SOFTWARE CHANGE REPORT (SCR)

SCR No. (Software Developer Assigns): PA-SCR-270	Software Title and Version: TPA 3.2.2	/Project No: 20-1402-762
Affected Software Module(s), Description of Problem(s): maxntime.i, releaset.f The number of TPA executive time steps is controlled by the maxntime.i include file. All files that reference this include file specify internal time array sizes as 201. This limits the flexibility of the code in doing time step dependent studies. Releaset.f has an internal time array size of 300 to accept the executive time steps. This change should be coordinated with the change to maxntime.i.		
Change Requested by: S. Mohanty Date: 5-28-99	Change Authorized by (Software Developer): S. Mohanty <i>[Signature]</i> 7/14/99 Date: 5-28-99	
Description of Change(s) or Problem Resolution (If changes not implemented, please justify): The maxntime.i size was set to 401 and the releaset.f array size was set to 402.

TPA Results for Total Groundwater Dose Using the Updated NEFTRAN and NEFTRAN from the TPA Version 3.2 Code

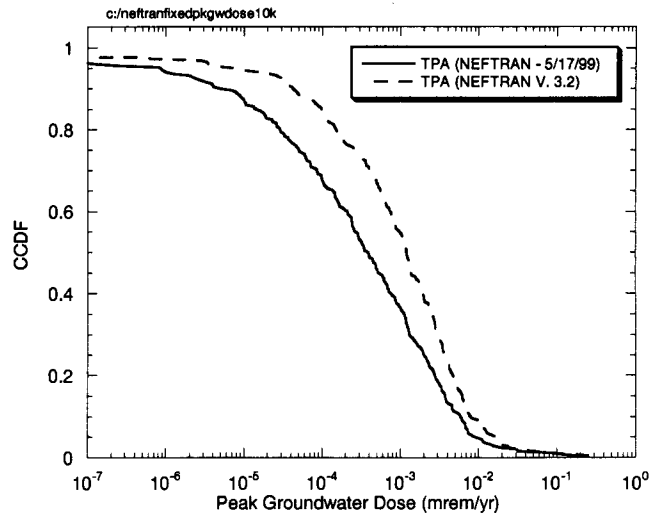
SCR No. (Software Developer Assigns): PA-SCR-260	Software Title and Version: TPA 3.2.2	Project No: 20-1402-762
Affected Software Module(s), Description of Problem(s): nefmks.f subroutines SETUP and CATCH. The dispersion of long paths is unduly controlled by the mixing zone source length. <i>along</i>		
Change Requested by: T. McCartin Date: 5-14-99	Change Authorized by (Software Developer): S. Mohanty Date: 5-14-99 <i>SW for Subhanta Mohanty 5/14/99</i>	
Description of Change(s) or Problem Resolution (If changes not implemented, please justify): subroutine SETUP: cc rwj 8-21-97 New line from T. McCartin via fax. cc SIGIR=SQRT(2.0*ALPHA(I)*VELISO(I,IR)/DT) cc rwj 5-14-99 "IF" block from T. McCartin via telecon. cc SIGIR=SQRT(2.0*ALPHA(I)*(VELISO(I,IR)**2)/path(i)) IF (LTOLX .EQ. 0) THEN SIGIR=SQRT(2.0*ALPHA(I)*(VELISO(I,IR)**2)/Y) ELSE SIGIR=SQRT(2.0*ALPHA(I)*(VELISO(I,IR)**2)/path(i)) END IF subroutine CATCH: cc rwj 8-25-97 New line from T. McCartin via telecon. cc V1 = VELISO(K,IR) + (-GA)*SQRT(2.0*ALPHA(K)*VELISO(K,IR)/DT) cc rwj 9-3-97 Add **2 for veliso per T. McCartin. cc rwj 5-14-99 "IF" block from T. McCartin via telecon. cc V1 = VELISO(K,IR) + cc & (-GA)*SQRT(2.0*ALPHA(K)*VELISO(K,IR)**2/path(k)) IF (LTOLX .EQ. 0) THEN V1 = VELISO(K,IR) + & (-GA)*SQRT(2.0*ALPHA(K)*VELISO(K,IR)**2/Y) ELSE V1 = VELISO(K,IR) + & (-GA)*SQRT(2.0*ALPHA(K)*VELISO(K,IR)**2/path(k)) END IF

Implemented by: Ron Janetzke <i>Ron Janetzke</i>	Date: 5-14-99	
Description of Acceptance Tests: Five pages are attached. 1) Plots from original NEFTRAN code show dose increase for subarea 7 and Np237 release rates for all subareas with subarea 7 far above the others. 2) Plots from original NEFTRAN code showing 4 nuclides with a range of Rd values, indicating the early release is more pronounced with higher Rd values. 3) Same as 2) with small dispersion length showing early release for large Rd value nuclides eliminated. 4) Same as 2) with modified NEFTRAN code showing early release for large Rd value nuclides eliminated. 5) Before and after plots for total GW dose, and peak GW dose.		
Tested by: Rob Rice <i>Rob Rice</i>	Date: 5-18-99
